# KITCHENER WATERLOO EXPRESSWAY LAUREL CREEK CULVERT AT K-W.E.

RE: INSPECTION  
MULTIPLATE PIPE  
ARCH CULVERT  
LAUREL CREEK  
CULVERT AT  
KITCHENER-WATERLOO  
EXPRESSWAY

Laurel Creek Culvert at  
Kitchener-Waterloo Expressway  
District No. 4 (Hamilton)  
Contract 69-102 - W.J. 67-F-3

FOUNDATION INVESTIGATION REPORT  
For Proposed Crossing At  
Laurel Creek and Dryden Blvd.  
Kitchener-Waterloo Expressway  
City of Waterloo; Co. of Waterloo  
District #4 (Hamilton)  
W.J. 67-F-3 - W.P. 641-64-1

FIGURE 1

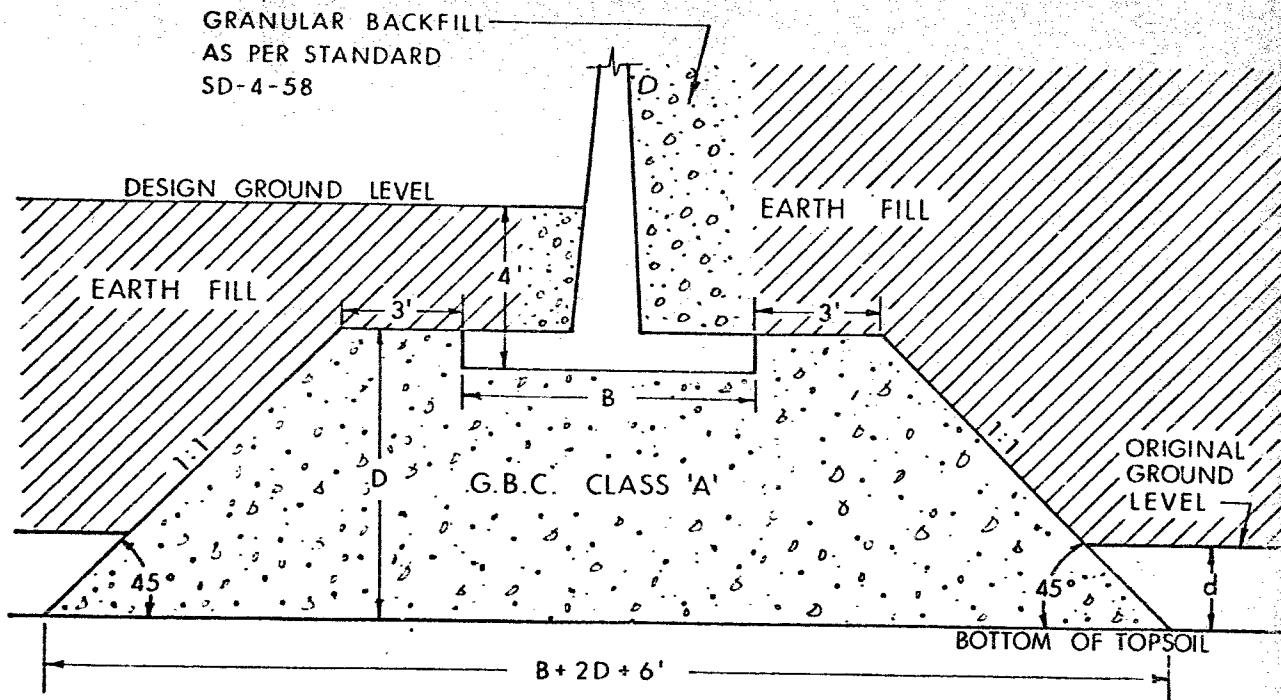
3) As an alternative to a piled foundation, the North portion of the North Retaining Wall may be founded on spread footings placed on well compacted granular fill. The attached standard has been prepared by the Foundation Section, showing the pertinent details. This method has been used successfully on a number of projects. For design purposes, a net safe footing pressure of 2 t.s.f. may be assumed. In computing frictional resistance to sliding, a coefficient of 0.55 may be assumed to apply between the Granular 'A' material and the footing base.
